ECN - ENGINEERING CHANGE NOTICE

During May and after we will upgrade our existing VGA controller board to also support **Digital Video Interface (DVI)** connection. A single input female **DVI-D** 24p connector.

Maritime Multi Display (MMD) models which are subject for engineering change:

Illustration:

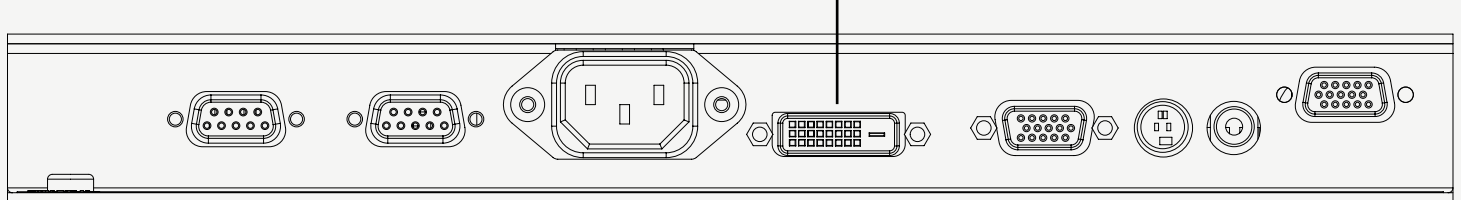
The **DVI** interface will give you the possibility to use digital RGB signal transfers instead of analog transfers, if your PC or compatible system supports it. This will give you sharper images, and accurate color representation, and a third input in addition to the already existing analog RGB Input and Video Input on our standard **MMD** models. All functions remains the same as previous models, and the new **DVI** interface is backwards compatible with your existing system, and there will be no change in part numbers.

Placement of the new DVI-D connector:
